November 22, 2019

Re: Docket No. 70-925; License No. SNM-928  
License Amendment Request to Redefine the Licensed Area

ATTACHMENT 1  
FIGURES 1 THROUGH 3

**FIGURE 3**  
**LICENSED AND CONTROLLED**  
**AREAS - SITE WIDE**

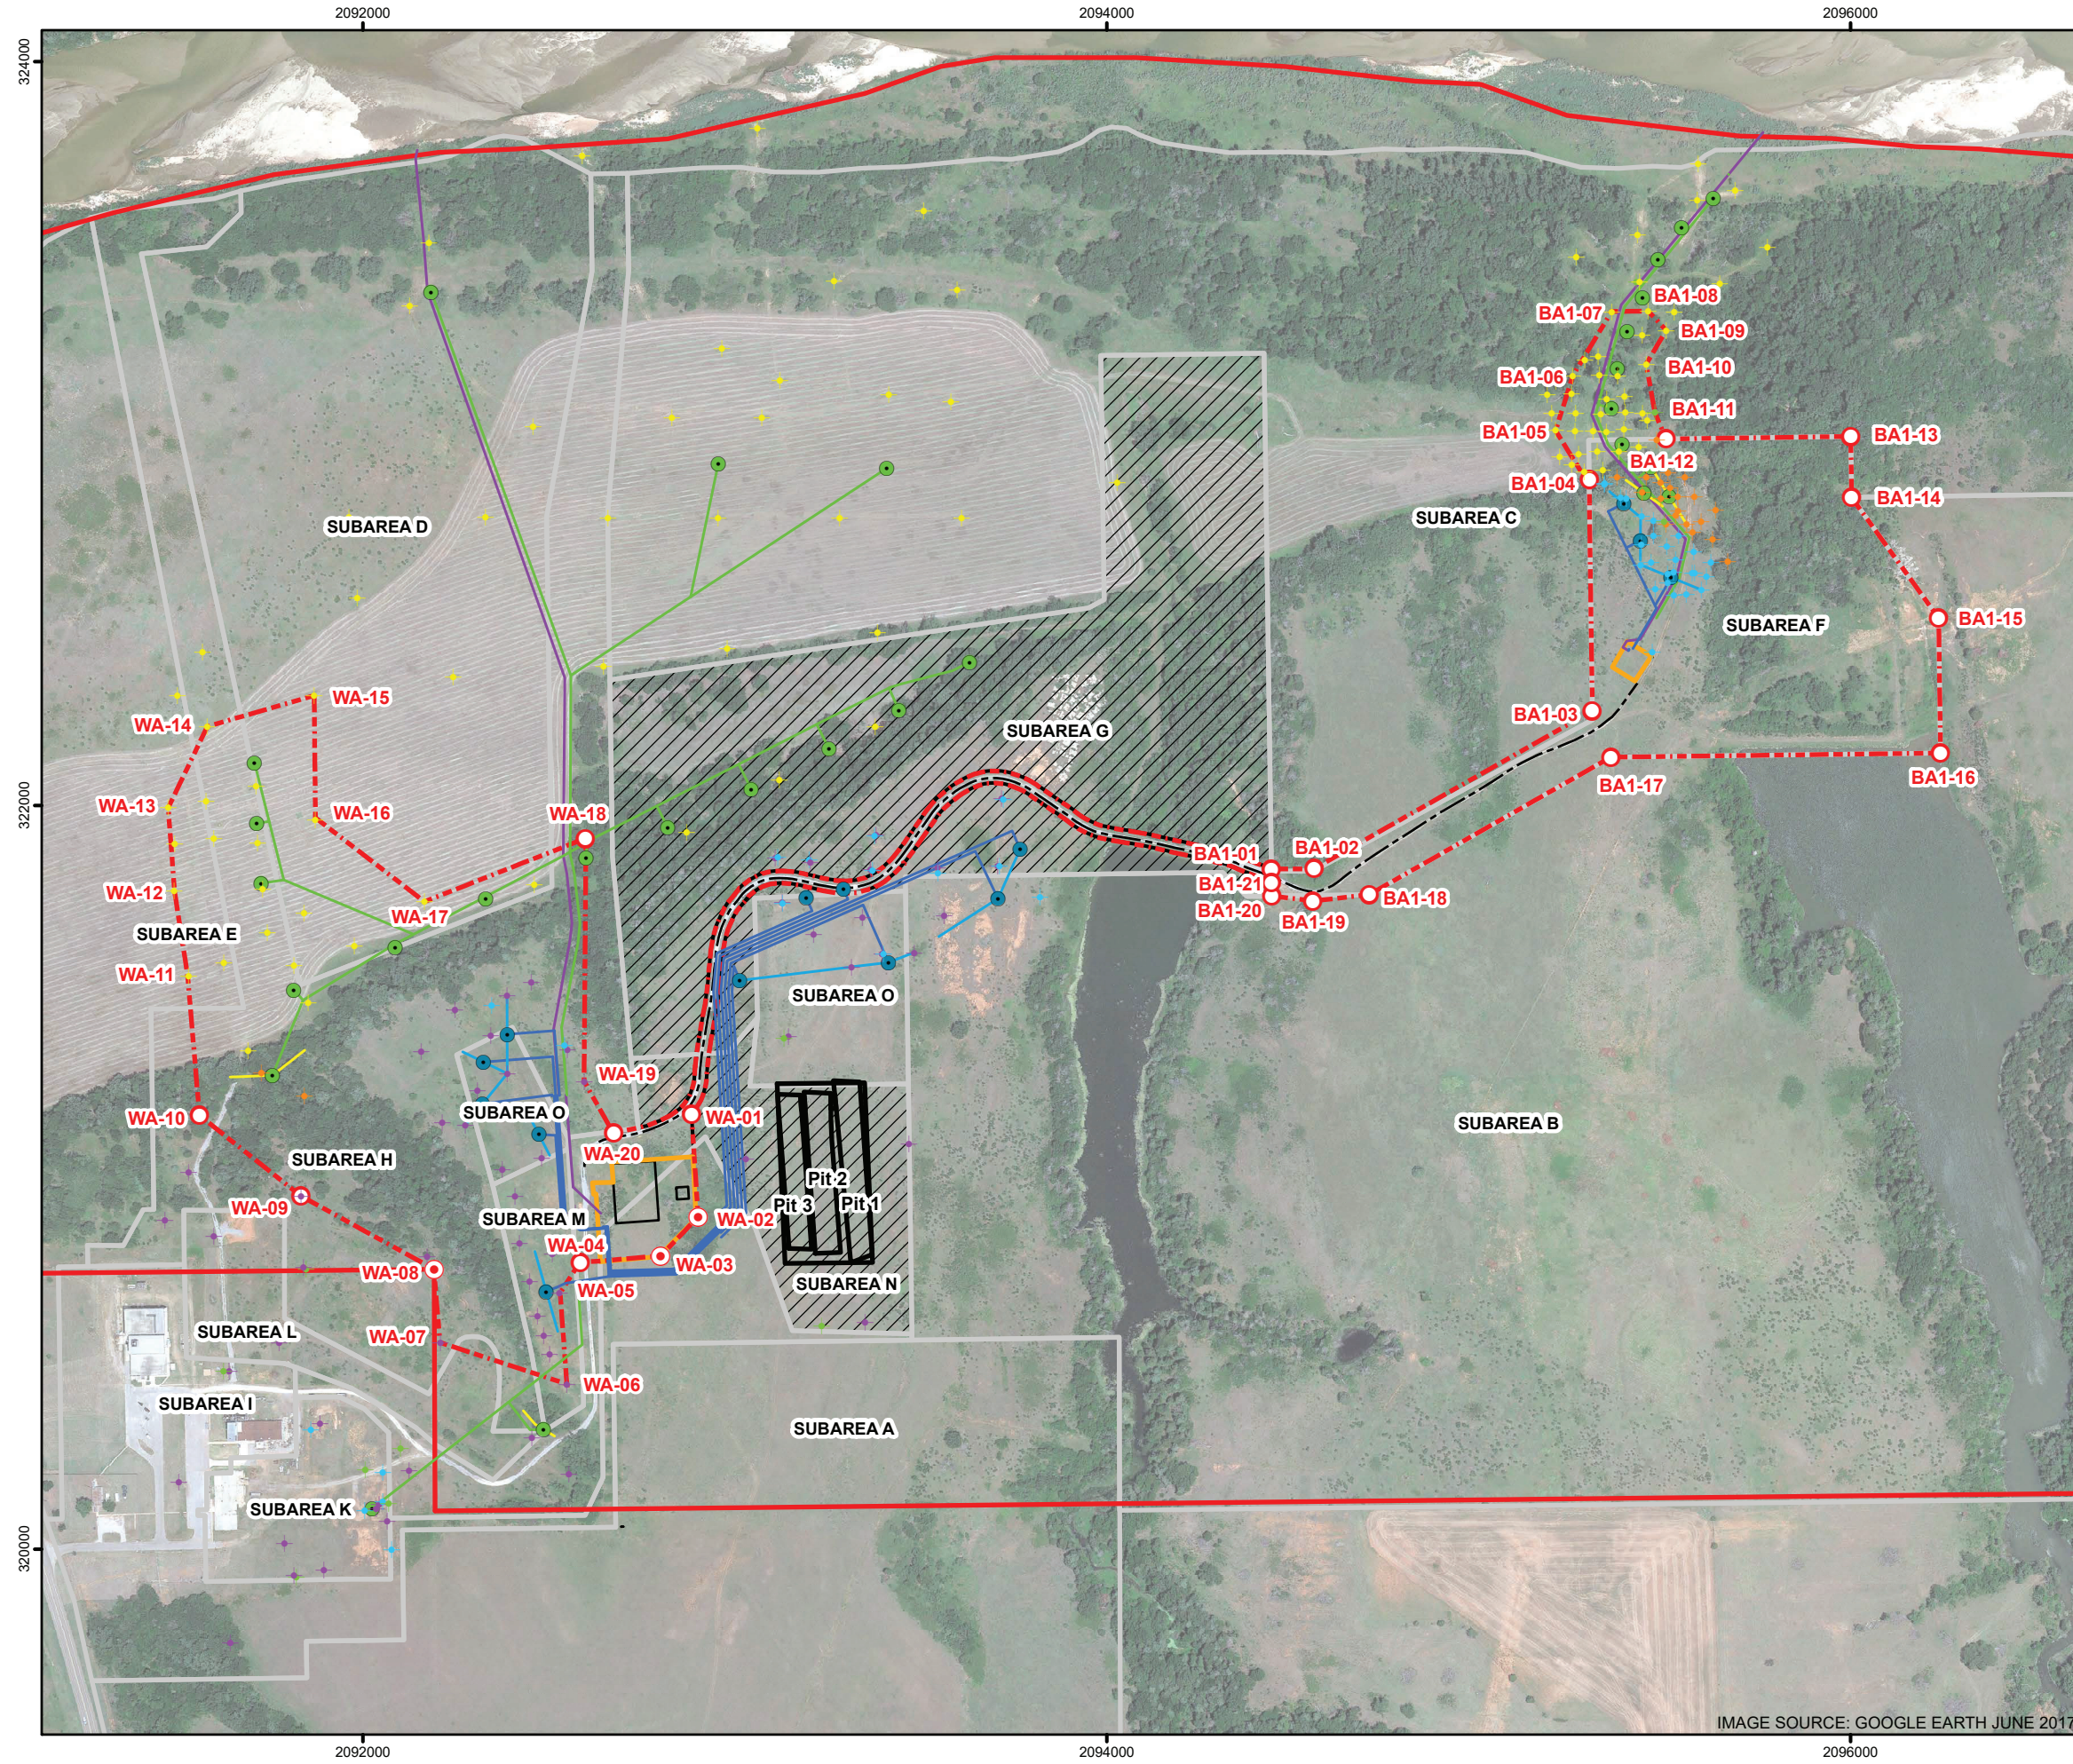
This figure depicts the licensed and controlled areas throughout the Site, including the entire extent of the Site road between BA1 and the WATF.

Cross-hatching provided in Figure 3 identifies those portions of Subareas G and N that would be released from License SNM-928 should the license be amended in accordance with this request.

EPM requests that License Condition 9 be amended to designate as the "Authorized Place of Use:" as the area depicted in Figure 3 of the November 22, 2019 license amendment request." (or equivalent language).
